Addendum 3

Wharton Regional Airport – Overlay Rehabilitation of Runway 14/32 and Taxiways

TxDOT CSJ 2513WHRTN

Key elements of this addendum include a modification to milling specifications to permit the use of milling to grade to allow for a more normalized (consistent thickness) overlay; removal of one of the two layers of seal coat (chip seal); and reduction of the milling depth from two inches to 1 1/2 inches, but with increased additional depth milling.

MATCHLINE STA 41+00 - SHEET DC-101

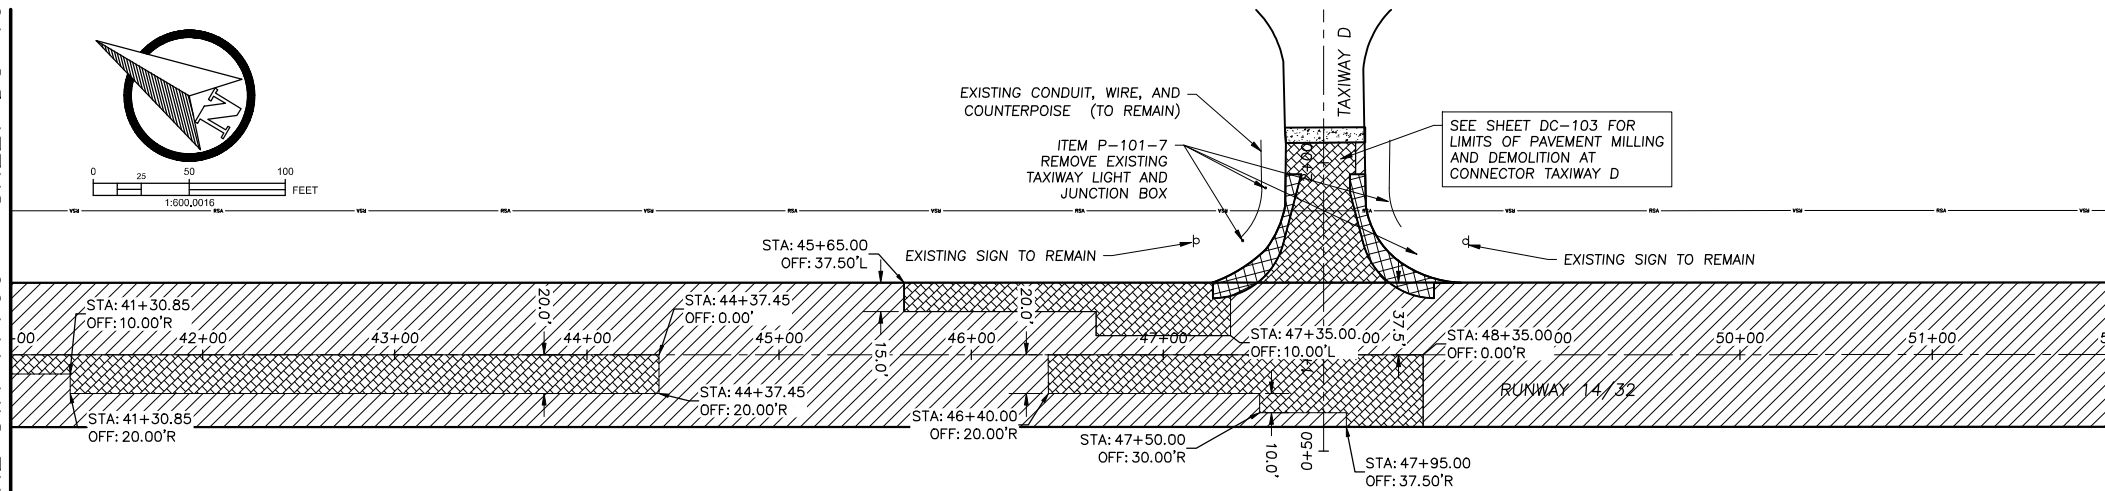
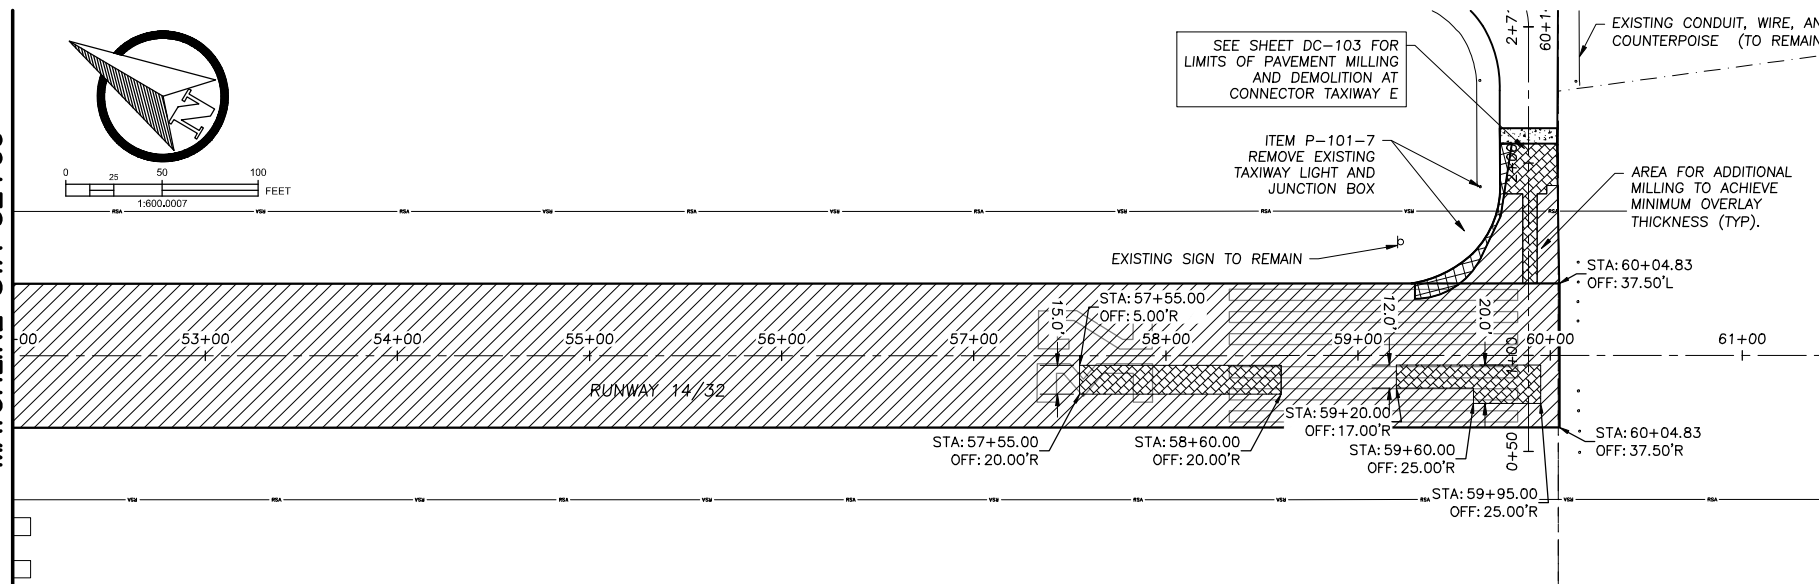
A7: Yes, at the Contractor's option, the existing pavement can be milled to a set depth below proposed grade to facilitate overlay at a set thickness, rather than milling a consistent depth and paving variable thicknesses to meet proposed grade. Under Item P-101 where milling is specified, the previous strikethrough has been reinstated to allow for milling to correct grade. See paragraph 3.5.b in Item P-101, and new General Note 4 on sheets DC-101 to DC-103.

1. STATION AND OFFSET ARE BASED ON RW CENTERLINE.
2. SEE SHEETS G-401 TO G-407 FOR PHASING REQUIREMENTS OF PAVEMENT REMOVAL AND LIGHTING MODIFICATIONS. WORK CAN ONLY OCCUR IN THE PHASE(S) IN WHICH THE WORK ITEMS ARE CONTAINED.
3. TO PROVIDE A MINIMUM SINGLE LIFT OF ASPHALT IN OVERLAY, SOME AREAS MAY REQUIRE DEEPER MILLING THAN SHOWN ON THESE SHEETS. LIMITS OF ADDITIONAL MILLING ARE BASED ON SURFACE MODELS AND MAY VARY. COORDINATE WITH RPR AND PROPOSE ANY ADDITIONAL AREAS OF MILLING TO THE ENGINEER FOR APPROVAL BEFORE MILLING.
4. AT CONTRACTOR'S OPTION, MILLING TO FINISHED GRADE MINUS 2 3/4 INCHES CAN BE CARRIED OUT TO NORMALIZE THE OVERLAY THICKNESS.

TITLE
PAVING SECTIONS AND DETAILS
 SHEET 1

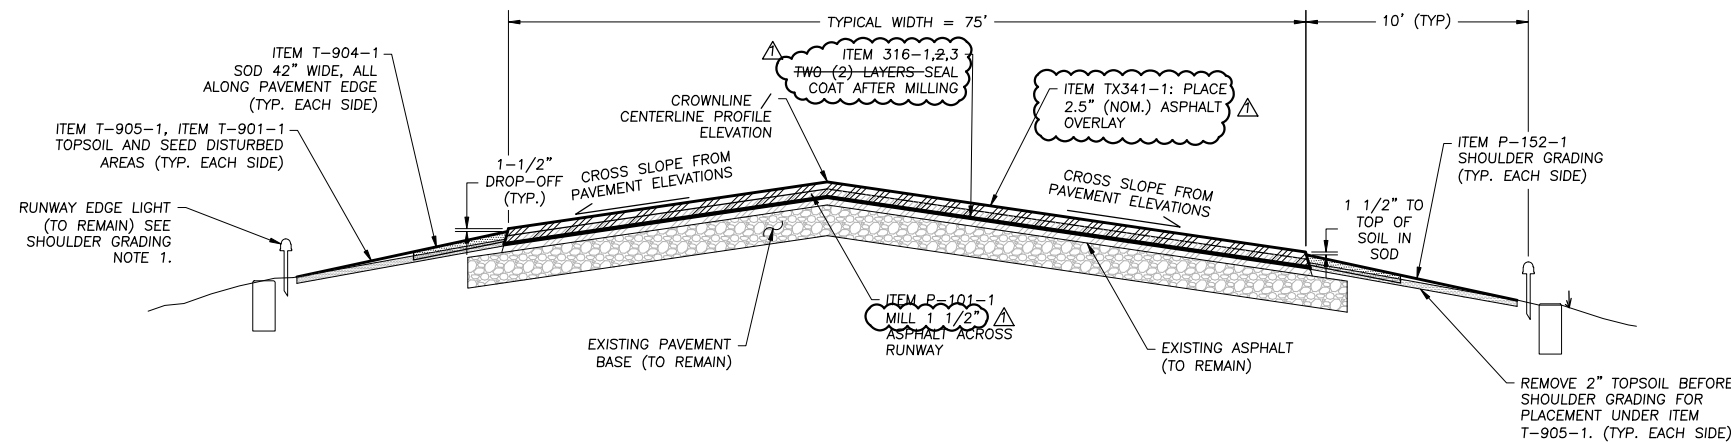
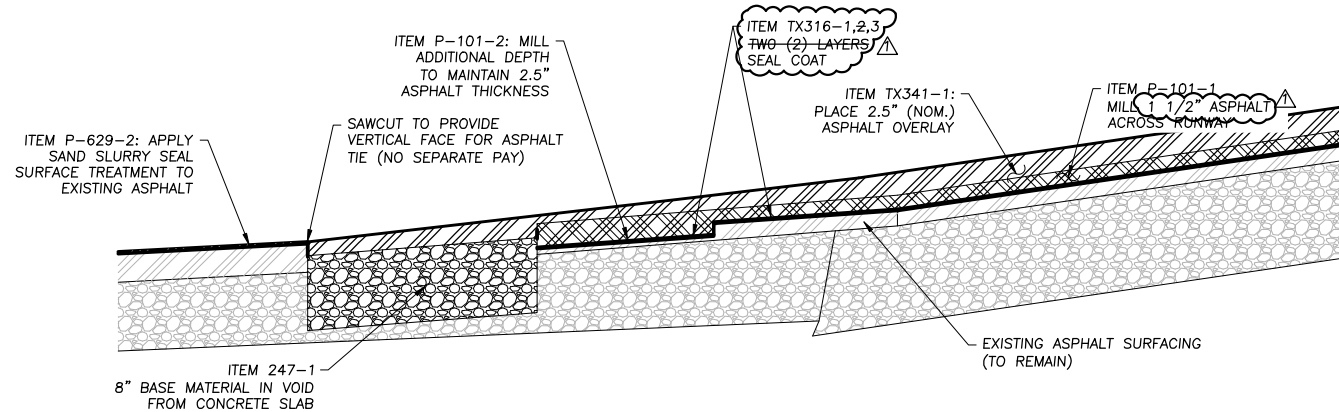
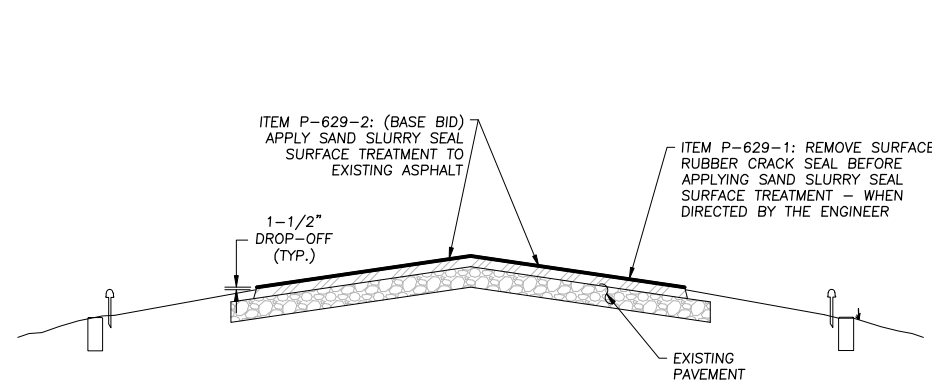
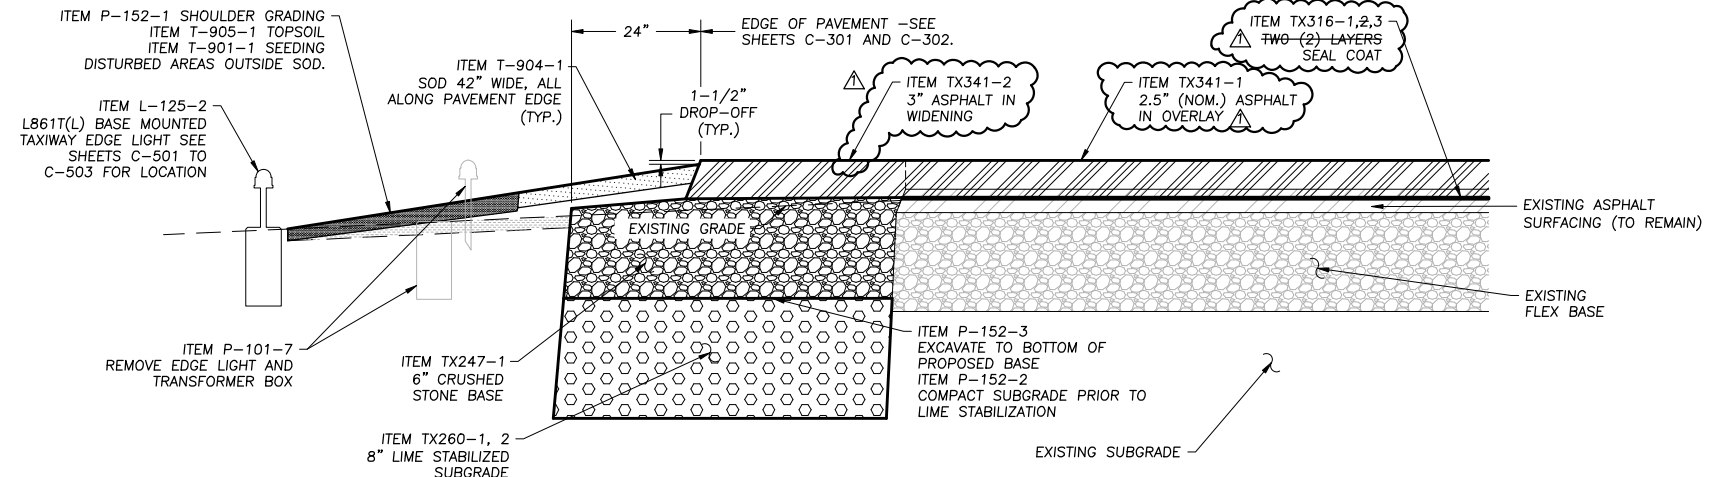
A3: Longitudinal grades along the runway overlay will be subject to Tx585, Surface Test Type B along both the centerline and the main gear wheel paths. Cross-slope grades on the runway and both longitudinal and cross-slope grades on the taxiways will be subject to Tx585, Surface Test Type A. See new TXDOT 341 Pavement Note 10 on sheet C-307.

A8: Mix designs are to be prepared following TEX-204-F, using either the Texas or the Super gyrotory methods. See updated TXDOT 341 Pavement Note 1 on sheet C-307.

Q10: The plans state that we are to use PG70-16 with no binder substitution. Is this PG correct?

A10: Binder for asphalt to now be PG76-22 due to requirements of the pavement performance but also based on availability. See updated TXDOT 341 Pavement Note 4 on sheet C-307.

- PREPARE ASPHALT MIX DESIGN FOLLOWING TEX-204-E USING TEXAS GYRATORY COMPACTOR.
- BINDER FOR LEVEL-UP TO BE PG64-22 UNDER ITEM TX306.
- AS 2-INCH LIFT, AGGREGATE FOR ASPHALT TO BE GRADE DG-D FINE SURFACE. AGGREGATE TO BE SAC B OR BETTER UNDER ITEM TX302.

- BINDER FOR ASPHALT SURFACING TO BE PG76-22 PG76-16 UNDER ITEM TX300. NO BINDER SUBSTITUTIONS WILL BE PERMITTED.
- AGGREGATE FOR ASPHALT SURFACING TO BE GRADE DG-D FINE SURFACE. AGGREGATE TO BE SAC A OR BETTER UNDER ITEM TX302.
